RECEIPT DATE: 5/10/18 **ONSITE SEWAGE DISPOSAL SYSTEM**

PROPERTY ADDRESS: 1030 Fairlane Road

SUBDIVISION: Fairlane Farms

**SEPTIC SYSTEM  
 INSTALLATION SITE PLAN  
 LOT 24  
 1030 FAIRLANE ROAD  
 FAIRLANE FARMS**

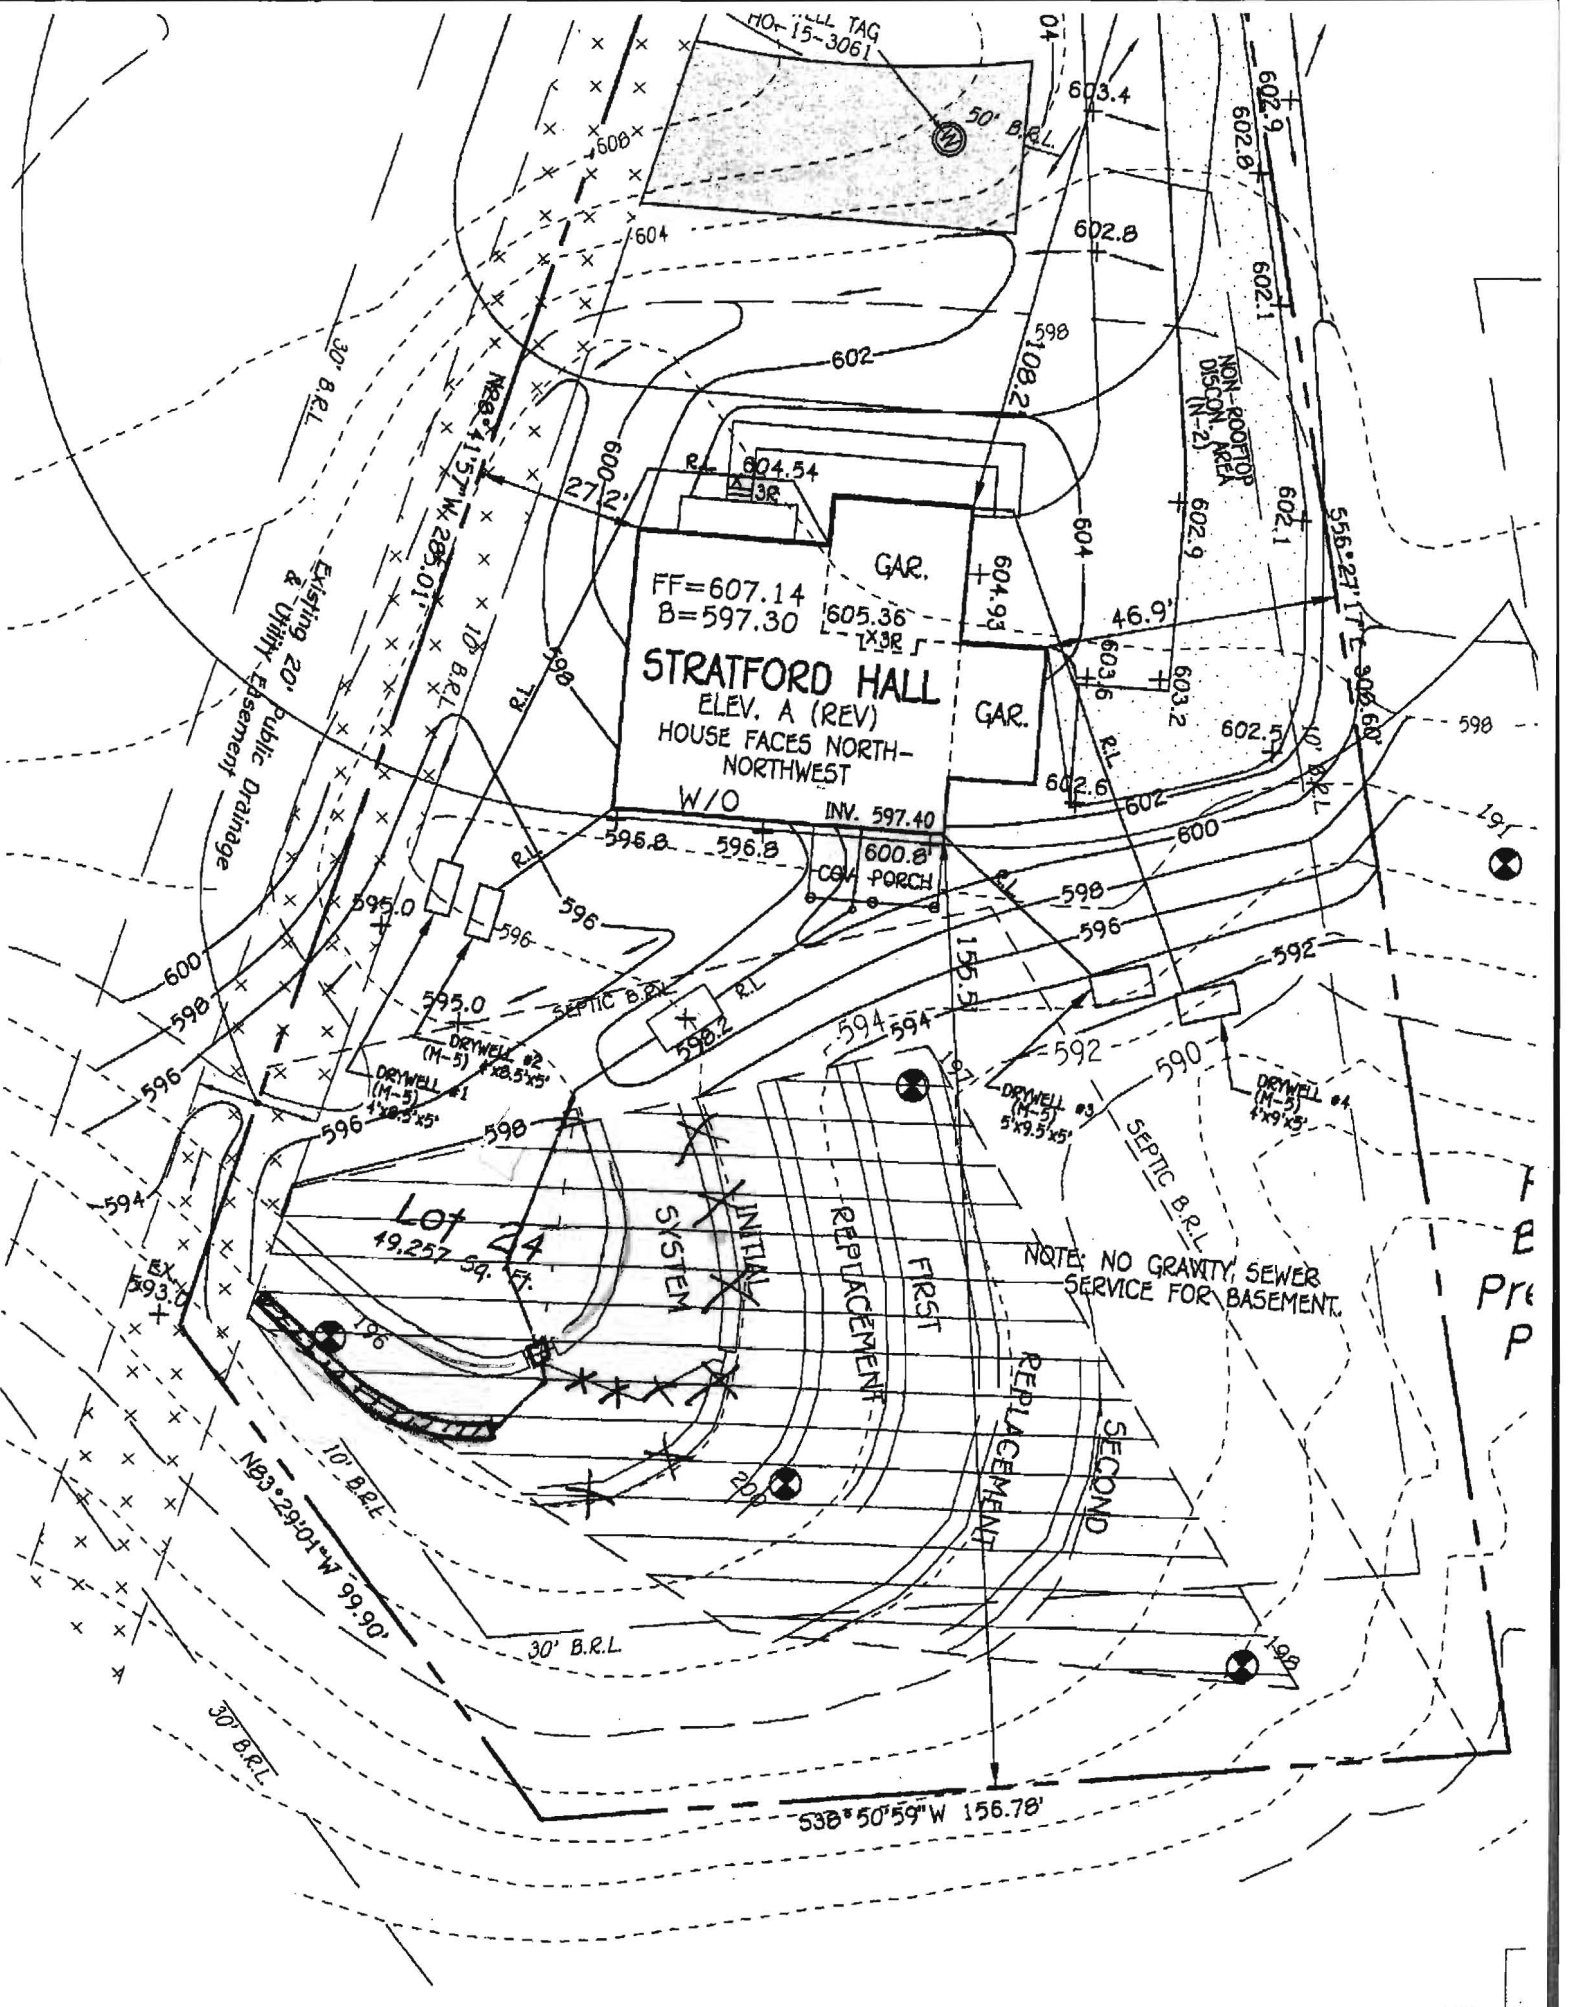
Tony,  
See attached layout. We will need 3 trenches at 43ft in length. I am using the application rate of 1.2gpd/ft<sup>2</sup> instead of 0.82gpd/ft<sup>2</sup>. I want to surround the initial system around perc test 196 which utilizes the 1.2gpd/ft<sup>2</sup>. Keep the two trenches as is running along contour 598'. Run the Distribution box in between these trenches. Add another 43ft trench below the SE most trench (see attached). Adjust the trench spec's as follows: Inlet invert 4ft below grade, trench bottom depth 6ft below grade. Fall will be close but holding 1% fall throughout. I am out of the office Monday if you have any questions, ill be back on Tuesday.

Only lot 24. I will need a revision on this too. I will forward you my sketch on trench/tank/dbox placement.

Just to clarify also, we will need 129LF of trench on this one.  
 $5\text{br} \times 150 = 750 \div 1.2\text{gpd}/\text{ft}^2 = 625\text{ft}^2 \div 3 = 208 \times .62(\text{sidewall red}) = 129\text{LF}$

You can eliminate the 2 trenches downhill on the initial system.

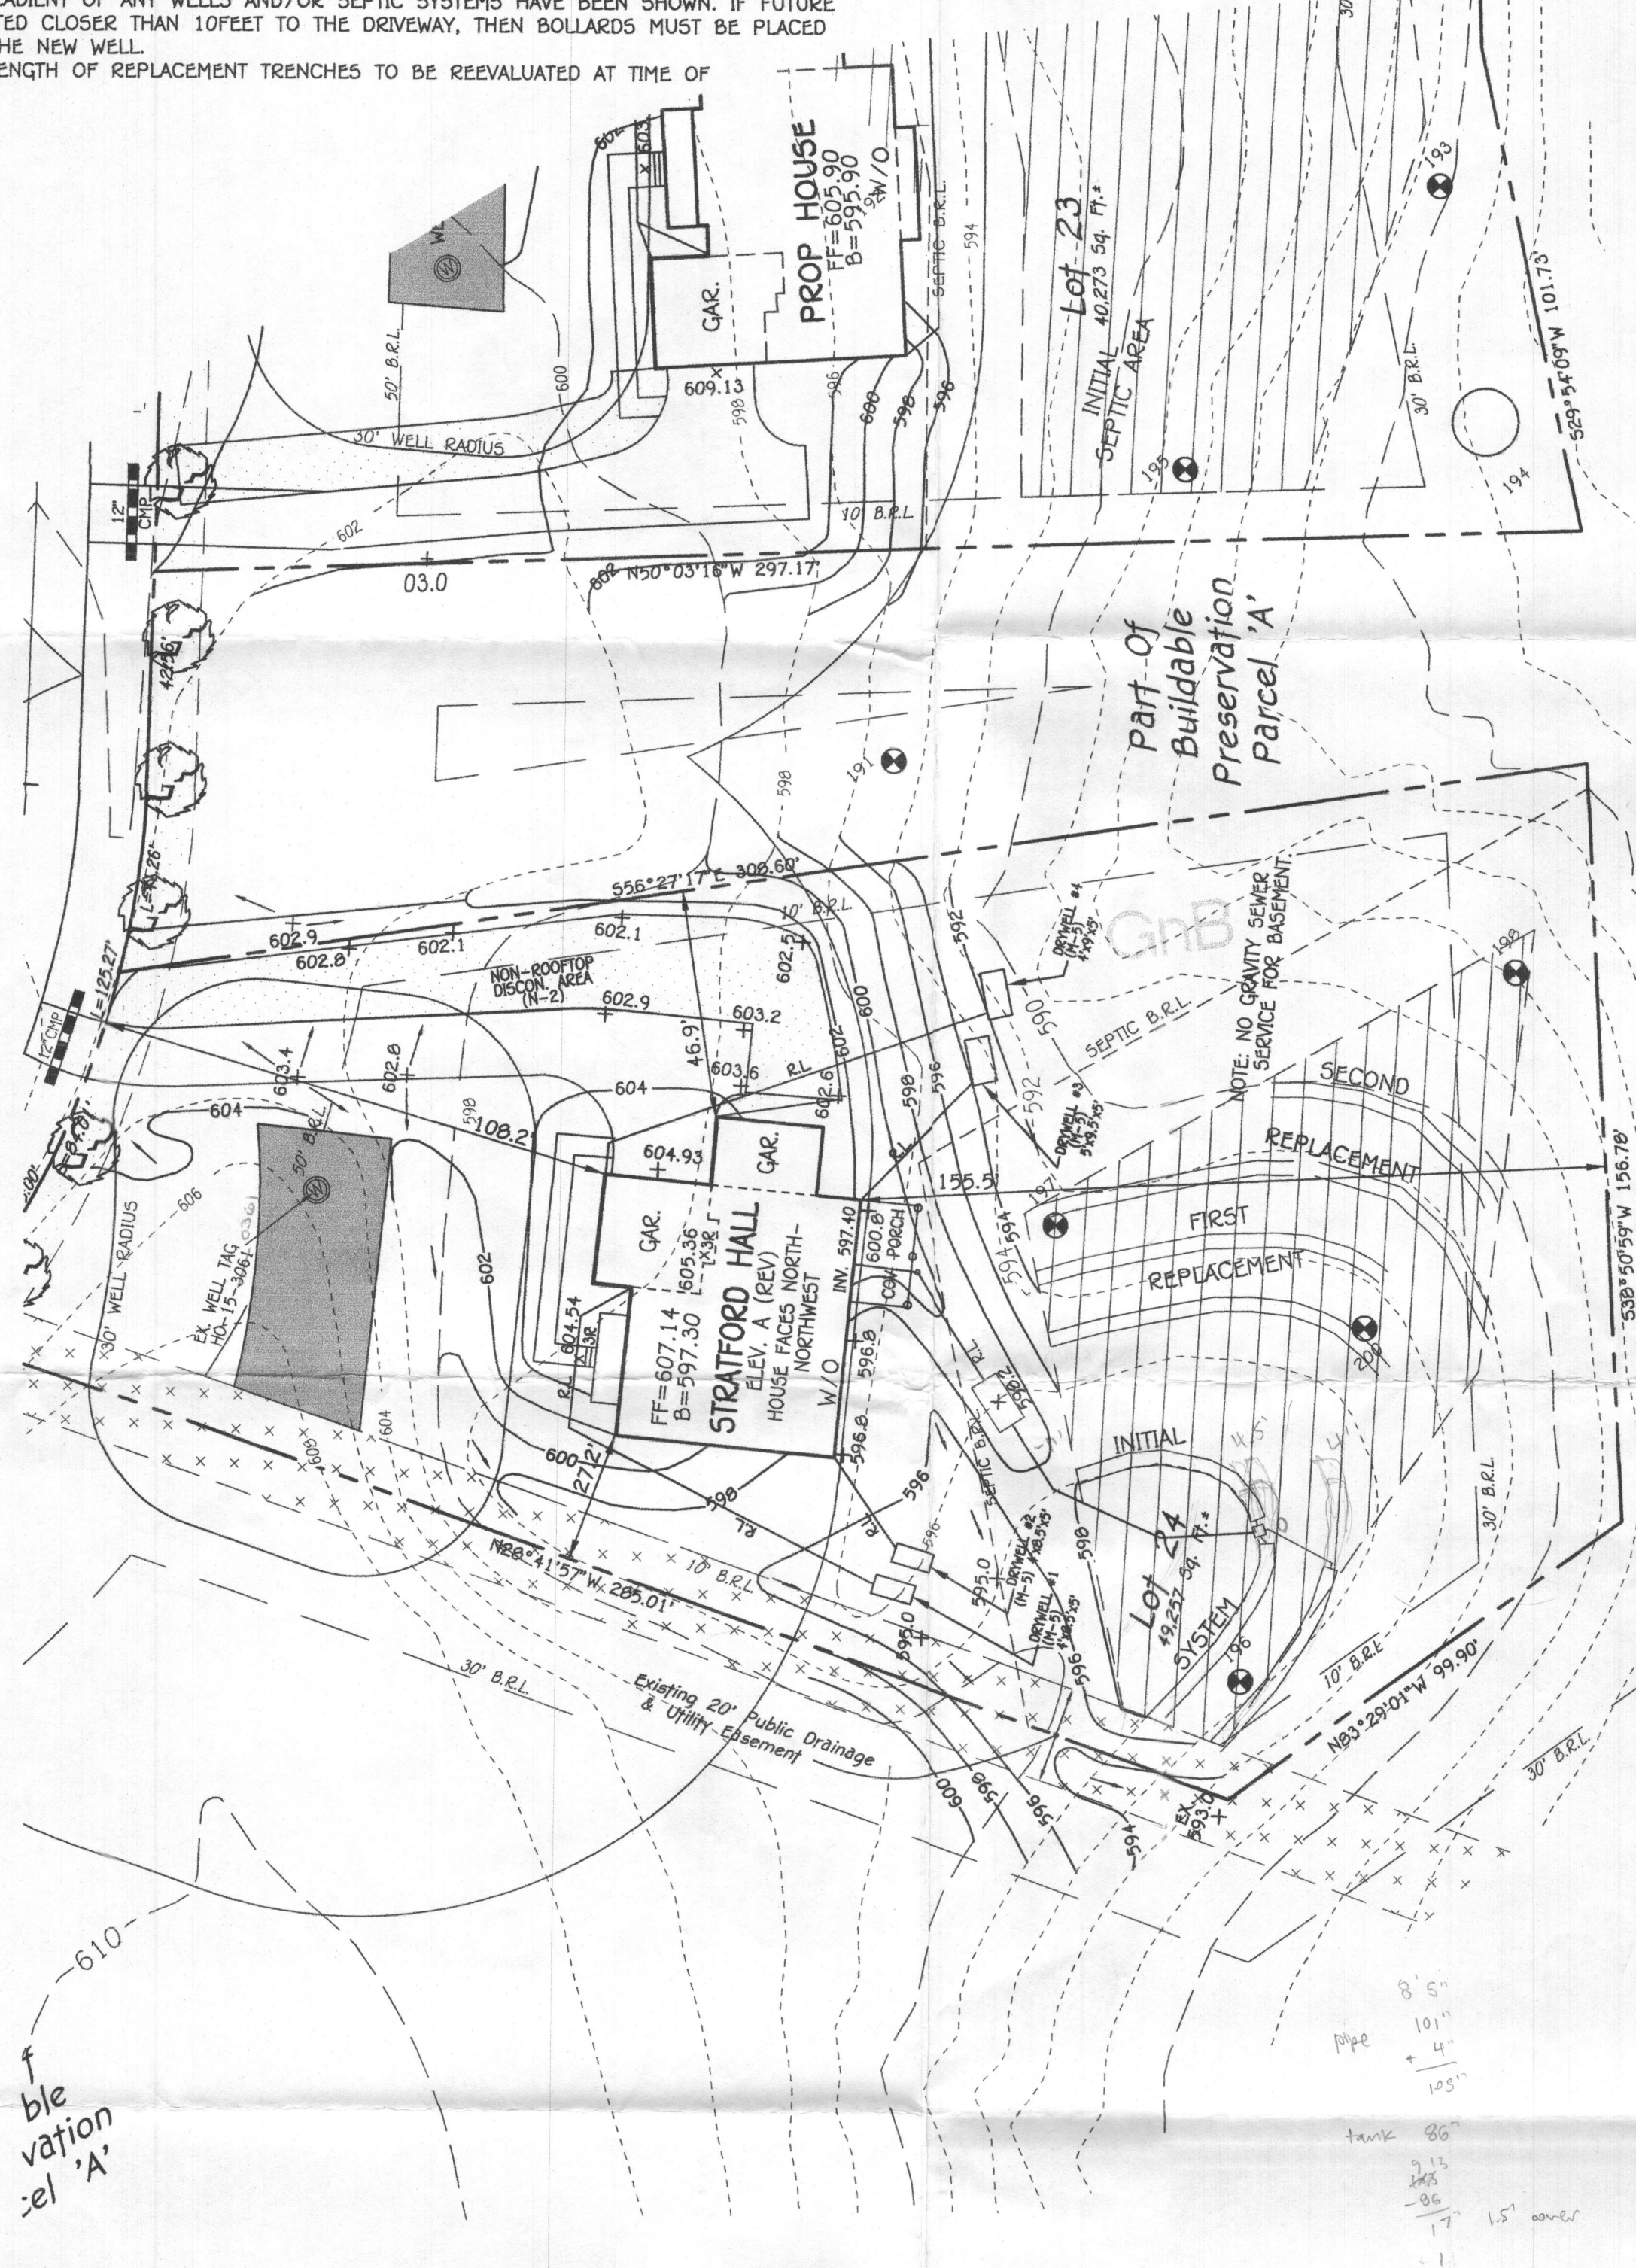
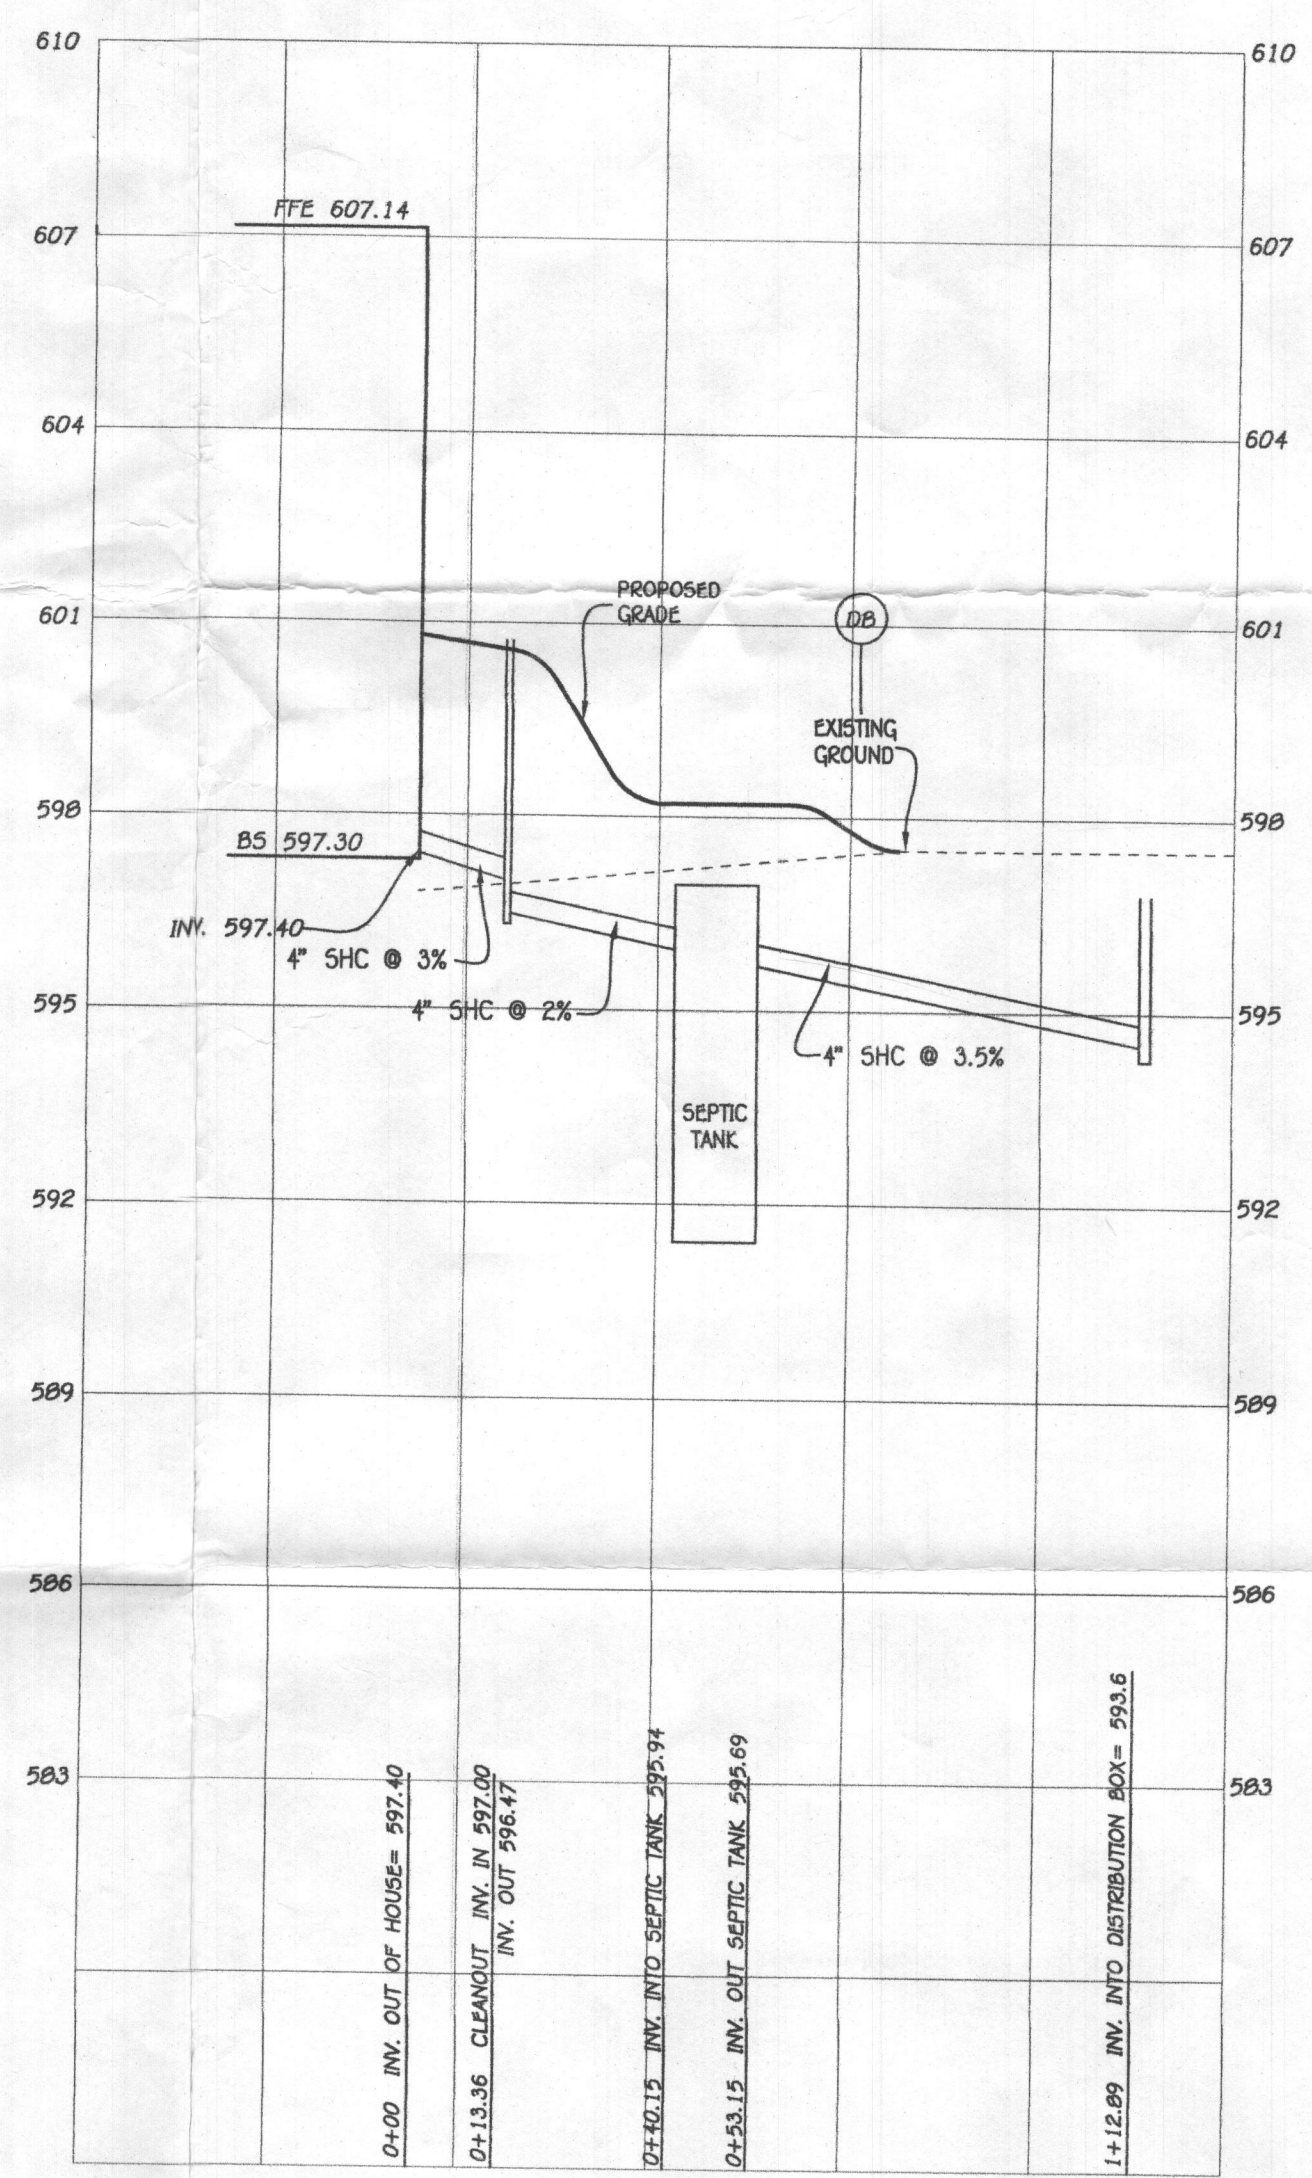
The OSDS Plan for Lot 24 does not match Kevin's specs. You are showing 4 trenches @ 39 ft. and using 3 foot of sidewall. Please revise to match or call to discuss.

We would like to see the d-box brought up to the 598 contour and we still want the trenches split due to the contour.

- 1.) Utilize the area at the top of the SDA by placing the d-box further up and start the trenches in the center (See attachment for layout recommendation).
- 2.) Re-exam invert elevation out of the house to ensure that it won't interfere the house foundation.
- 3.) Show additional step in calculation (i.e.  $937.5/3 = 312.5$ ).

- 1.) Match basement elevation 596.80 to 596.60 or vice versa
- 2.) Match well tag # on plan with note.
- 3.) Match invert elevations out of the house for the "Septic Profile" (594.97 or 592.05?)
- 4.) Match invert elevations in profile with invert elevations listed next to trench data.
- 5.) Raise trench invert up to 2 feet in order to utilize the 3 foot reduction credit by showing this in the "Initial Trench Detail". Adjust elevations accordingly.
- 6.) Make bottom depth 5 feet (not 7 feet) for "Initial Trench Detail"
- 7.) Entire well box must meet 10 foot setback to driveway.

**INITIAL SYSTEM**  
 SEWAGE DISPOSAL SYSTEM DATA DESIGN FOR 5 BEDROOMS  
 LOADING RATE = 5 BEDROOMS X 150 GPD/BEDROOM = 750 GPD  
 APPLICATION RATE = 1.2  
 EFFECTIVE SIDEWALL BEGINS AT 4 FEET  
 TRENCH DEPTH = 6 FEET  
 TRENCH WIDTH (W) = 3 FEET  
 EFFECTIVE DEPTH (D) = 2 FEET  
 SF OF DRAINFIELD = 750 GPD / 1.2 = 625 SF  
 COEFFICIENT OF REDUCTION OF TRENCH LENGTH = (W+2)/(W+1+2D) = (3+2)/(3+1+(2x2)) = .62  
 TRENCH LENGTH = 208 SF x .62 = 129 FEET  
 (USE 3 TRENCHES AT 43 LF.)  
 TRENCH SPACING = 2D+W = ((2x2) + 3) = 7' USE 10'
